[Docket No. 2001-SW-40-AD; Amendment 39-12793; AD 2002-13-05]

Airworthiness Directives; MD Helicopters, Inc. Model 369D, 369E, 369F, and 369FF Helicopters

ACTION: Final rule.

Figure 1 - Inspection Location

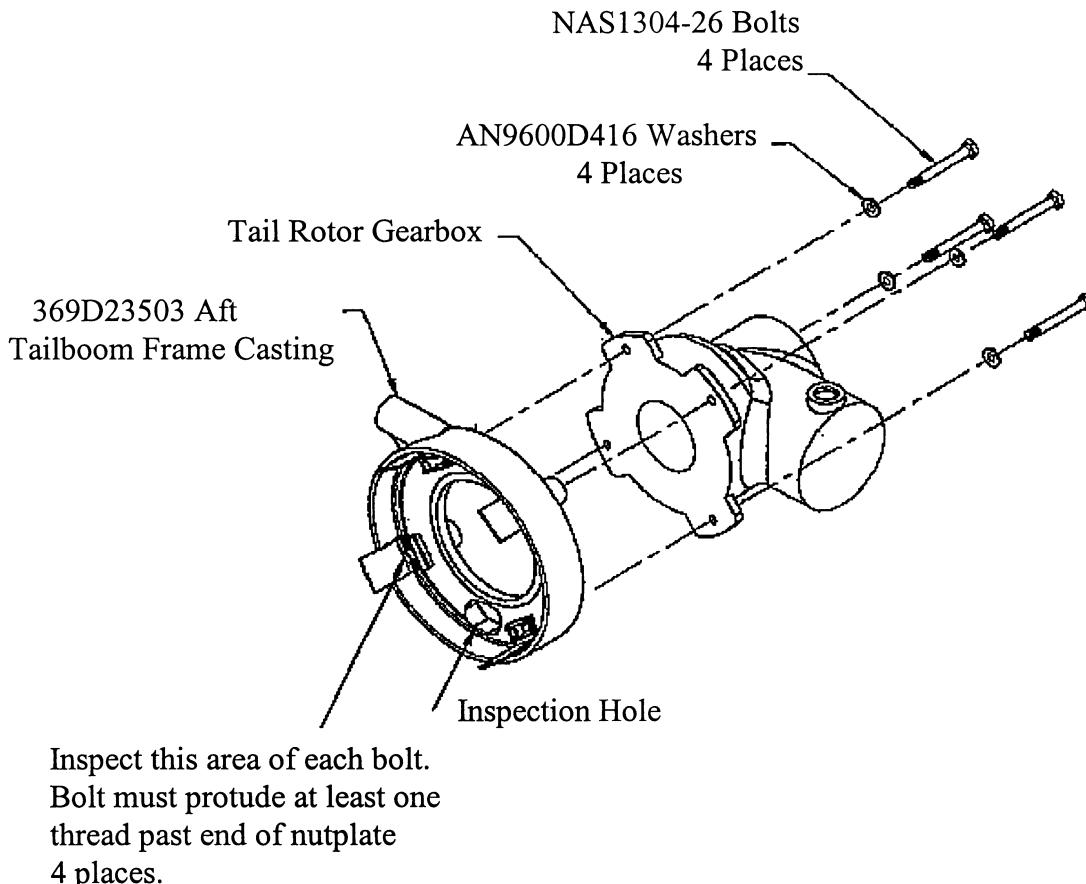
(2) Remove the tailboom control rod and determine the number of bolt threads protruding from each nutplate on the internal surface of the aft tailboom frame casting, P/N 369D23503, as shown in Figure 1 of this AD. At least one thread must protrude. If more than four threads protrude, add an additional washer, P/N AN960D416, under the bolt head. Torque the bolt to 100–110 in-lbs, and reapply a slippage mark. See Figure 1:

(b) Between 2 and 10 hours TIS after accomplishing the requirements of paragraph (a) of this AD, inspect the torque on each bolt by applying 100 in-lbs. If any bolt movement occurs, retorque the bolt to 100–110 in-lbs and reapply a slippage mark. Reinspect the torque between 2 and 10 hours TIS thereafter until no bolt movement occurs.
